## SERVICE BULLETIN NO. 0103

SUBJECT: Positive Battery Cable Shorting to Frame

Models Affected:	Serial Numbers Affected:
All propane powered machines in serial number range	53799 & up

Positive battery cable in incorrect orientation

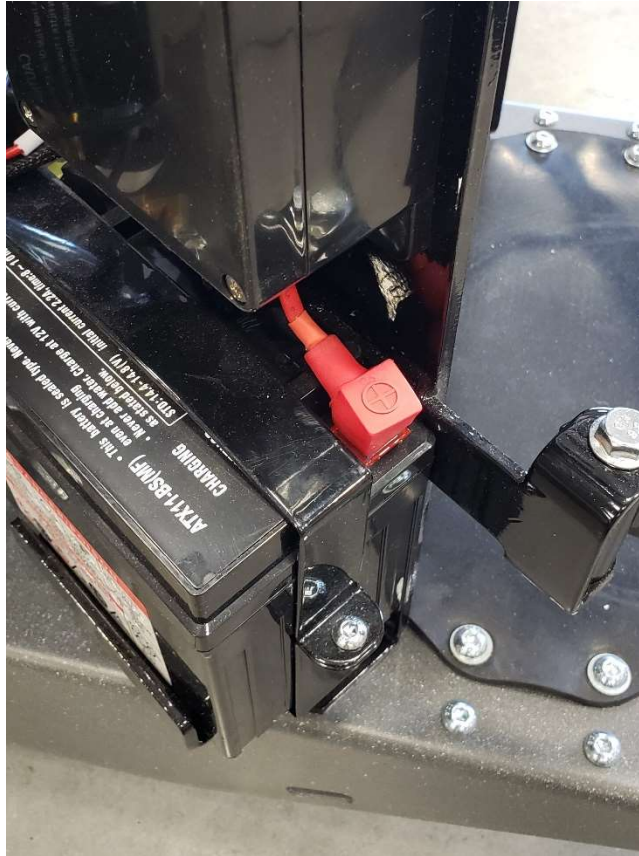
04-24-2023: Identified problem in which the positive battery cable was installed in the incorrect orientation causing some models to experience contact between the cable and frame. This could cause battery short, which will likely cause overheating of the throttle cable's protective sheathing, leading to melting.

**SOLUTION:** Identify positive battery cable and reorient it into correct position using a copper or steel washer to the battery terminal as a spacer to lift the cable, allowing for contact while in proper orientation.

Addition of 1 copper/steel flat washer of about 3mm

Positive battery cable in correct orientation, reattached to lifted terminal contact
